HCCSC Salamonie HVAC Replacement and Renovation

Project # 2024.0002
10-08-2024

ADDENDUM NO. 02

ELECTRICAL POWER PLAN - PENTHOUSE
SCALE: 1/4" = 1'-0"

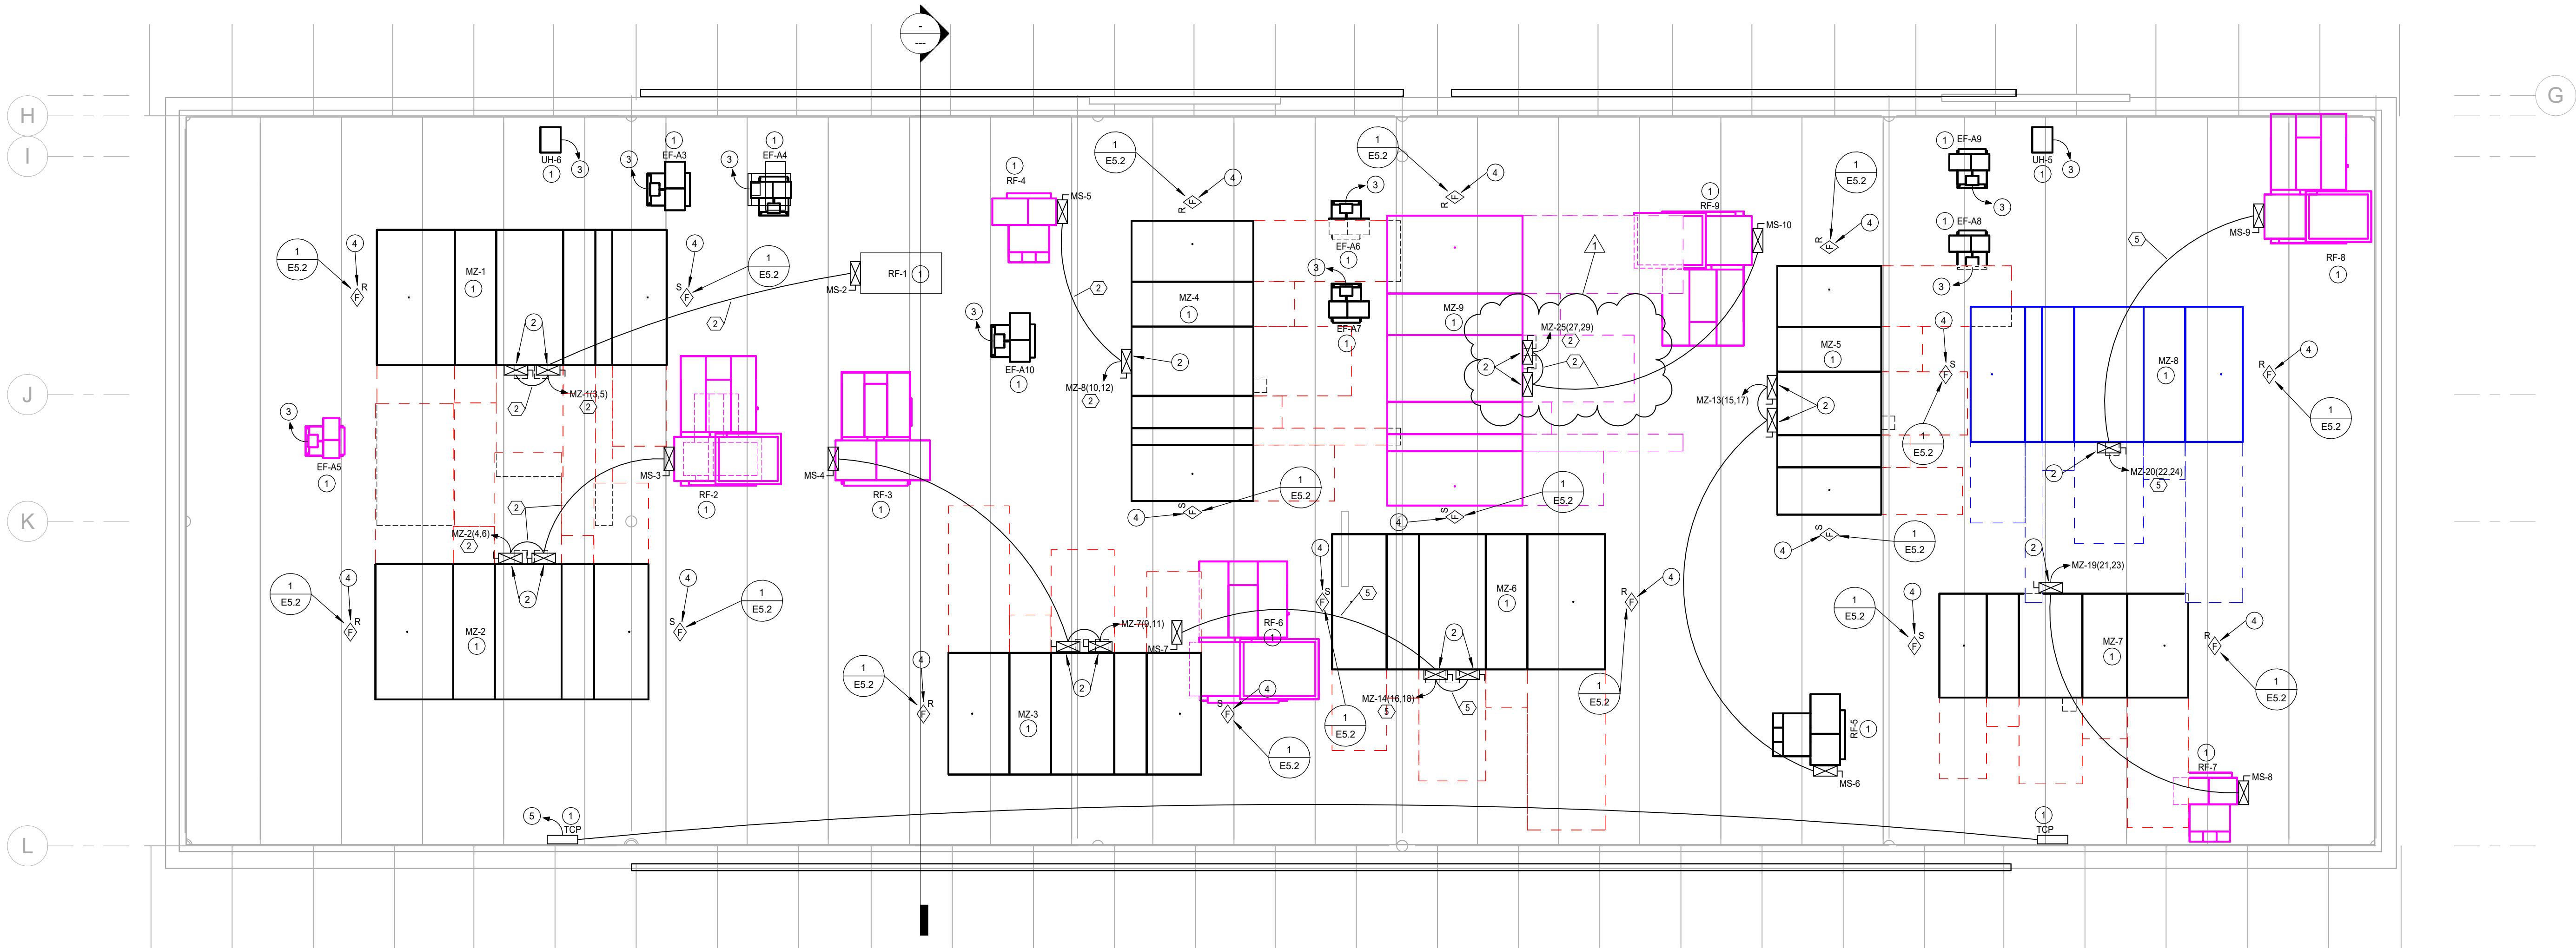
- Item: E-2.6**
Location: Electrical Drawing: E1.4
Description: Revision: Revise Electrical Power Plan - Penthouse as shown on attached revised sheet E1.4.

E2.3

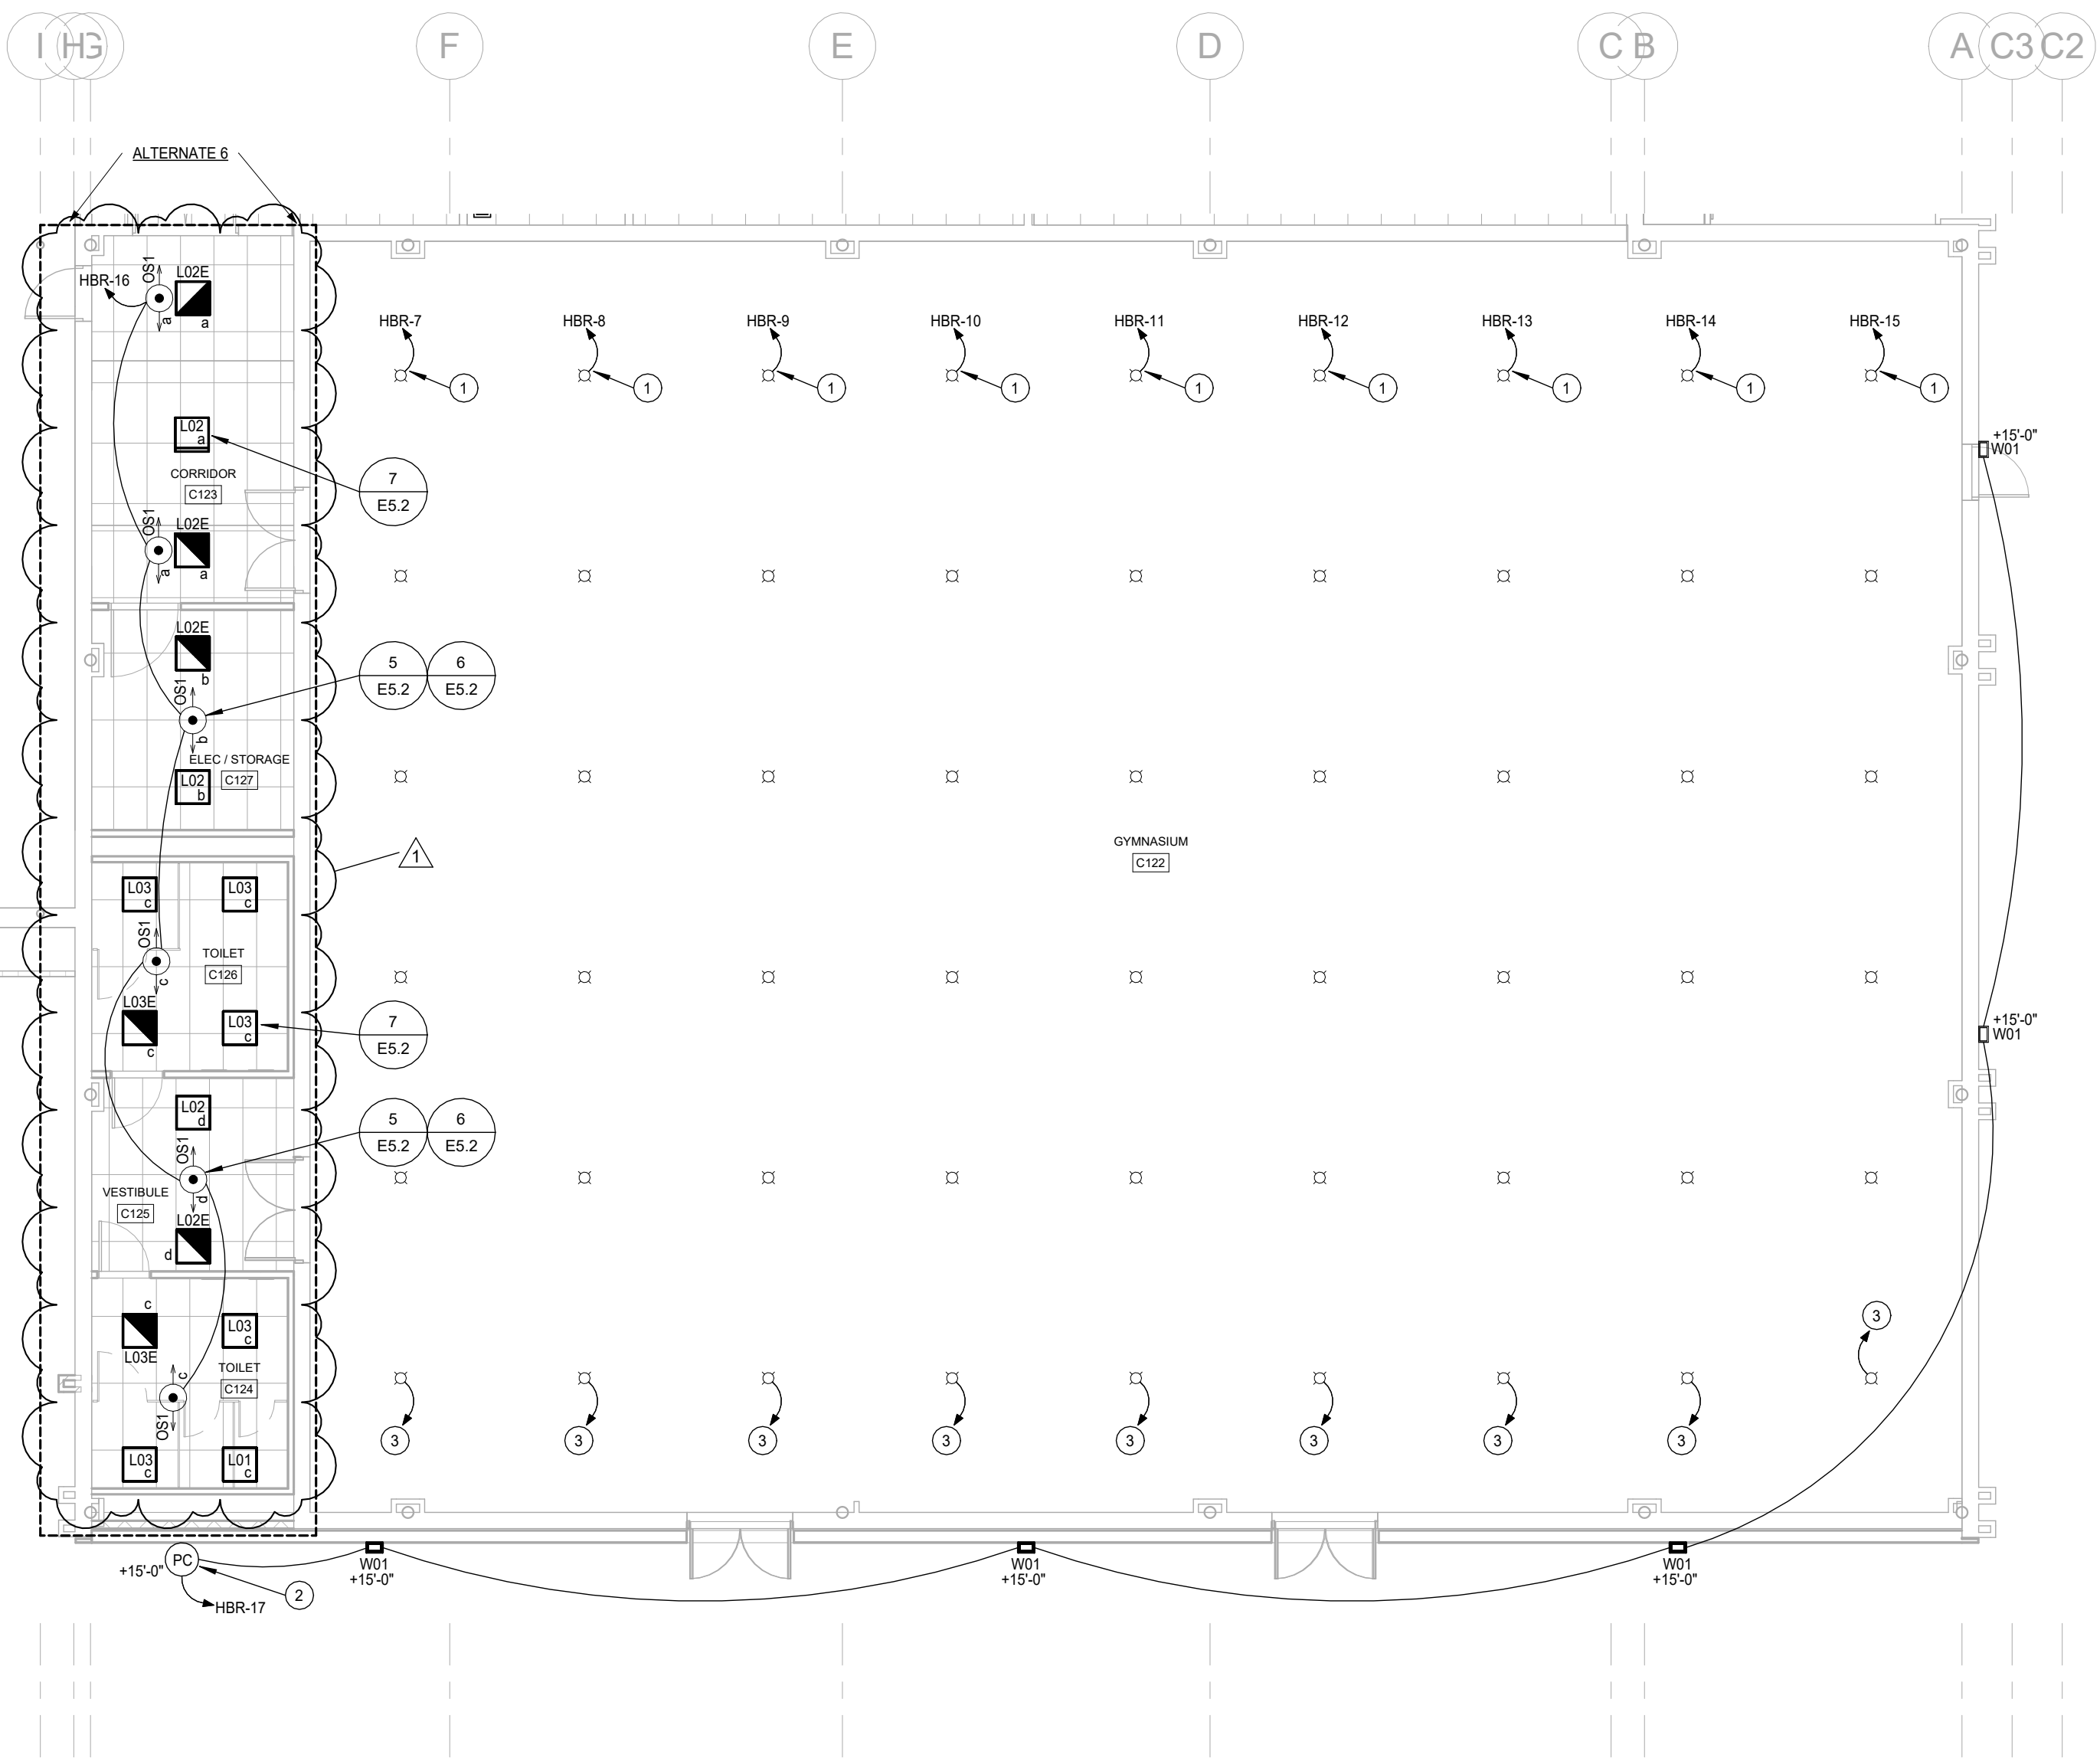
- Item: E-2.8**
Location: Electrical Drawing: E2.3
Description: Revision: Revise Electrical Lighting Plan – Alternate 3 & 6 as shown on attached revised sheet E2.3.

SHEET
E2.5

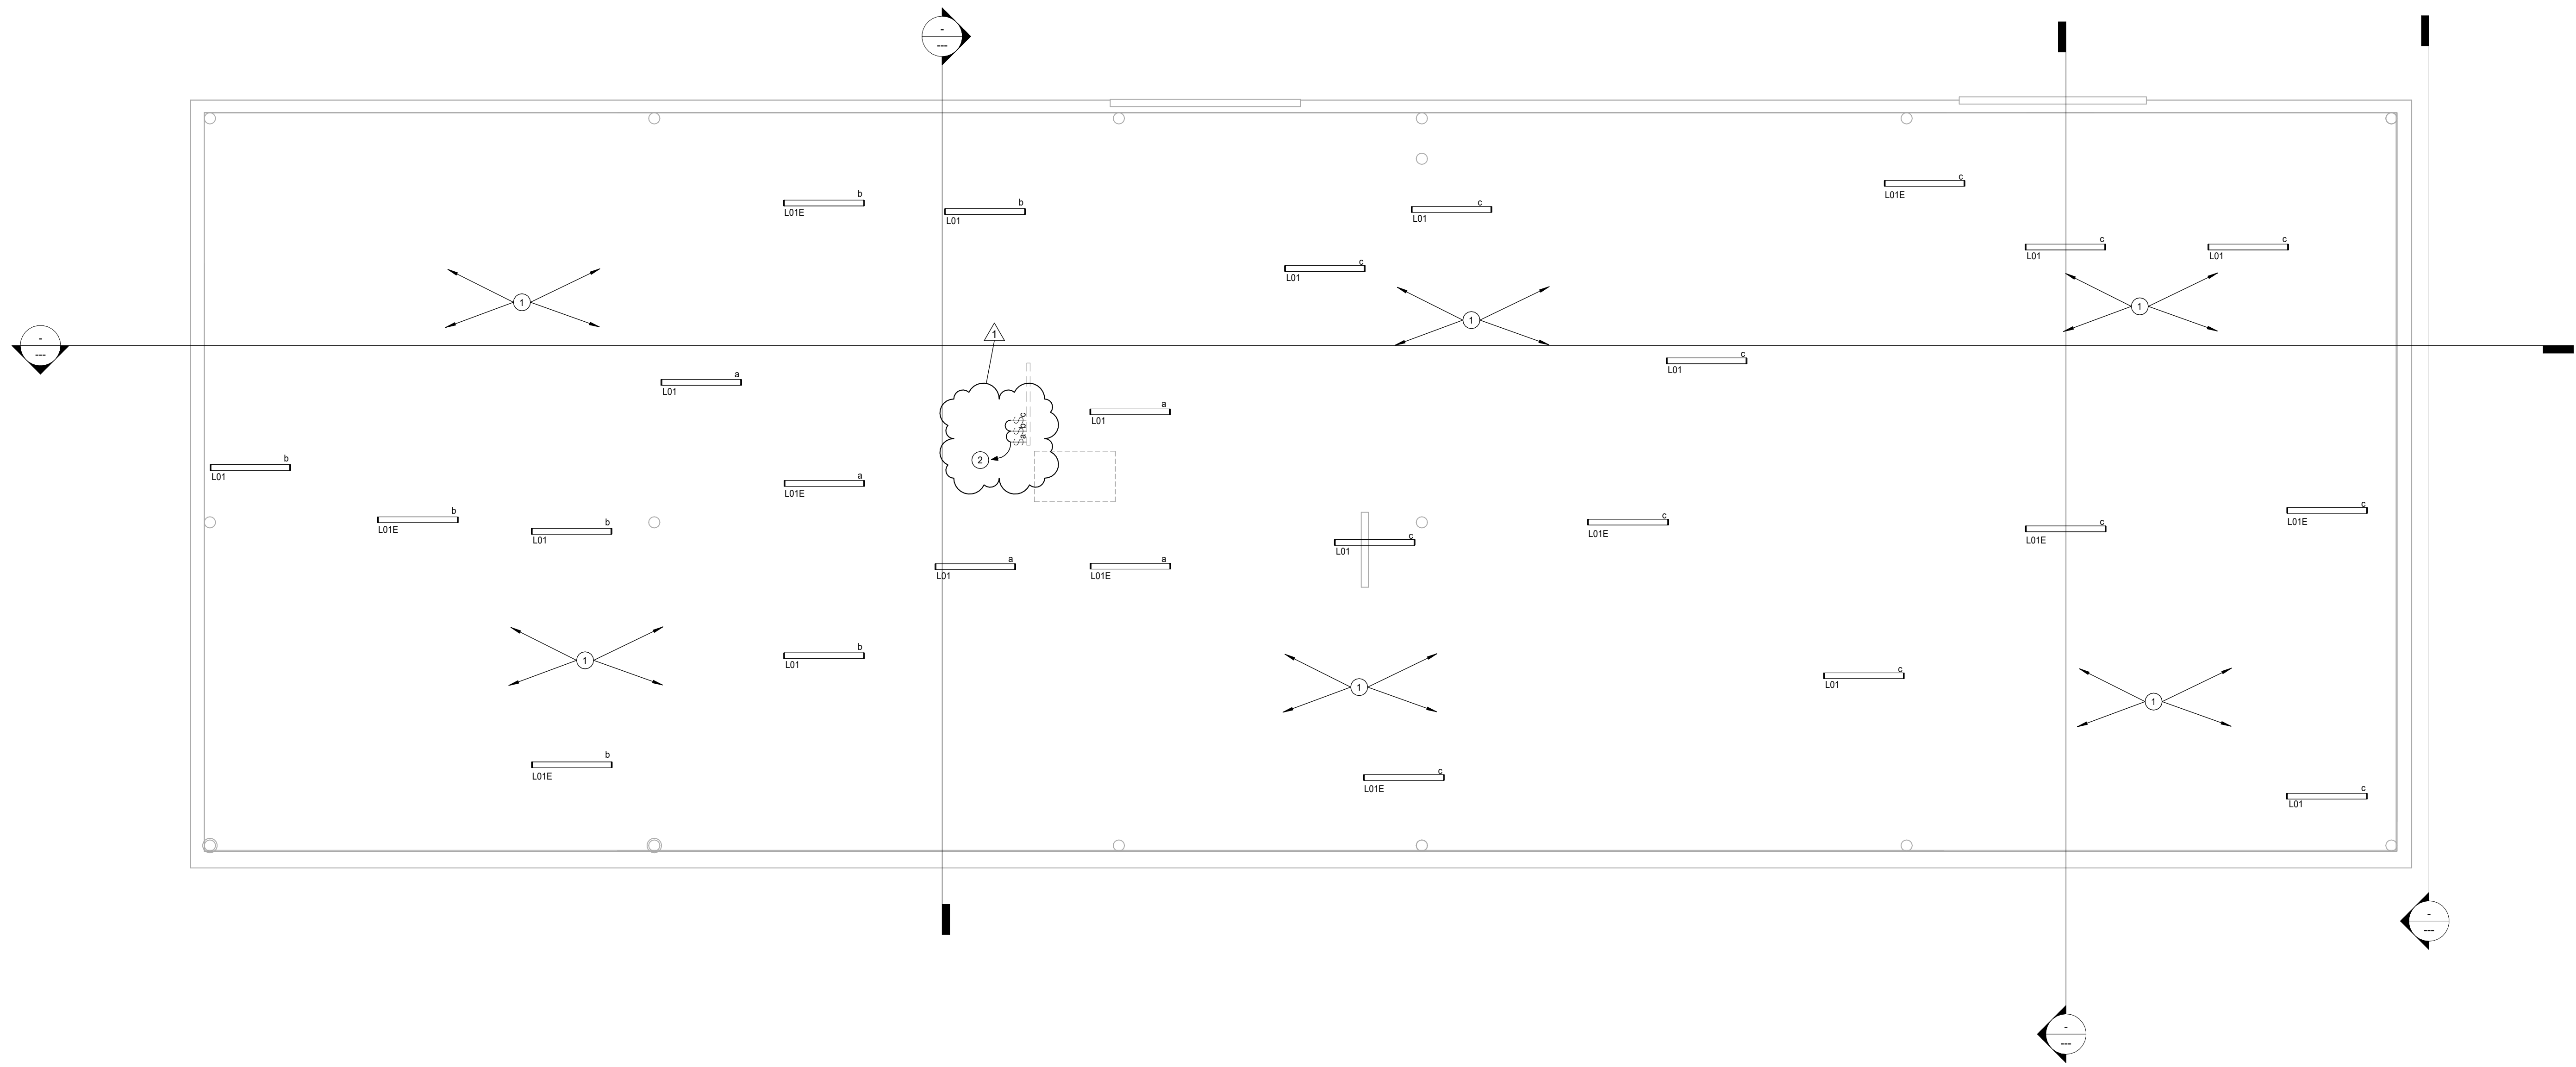
- Item: E-2.9**
Location: Electrical Drawing: E2.5
Description: Revision: Revise Penthouse Electrical Lighting Plan as shown on attached revised sheet E2.5.
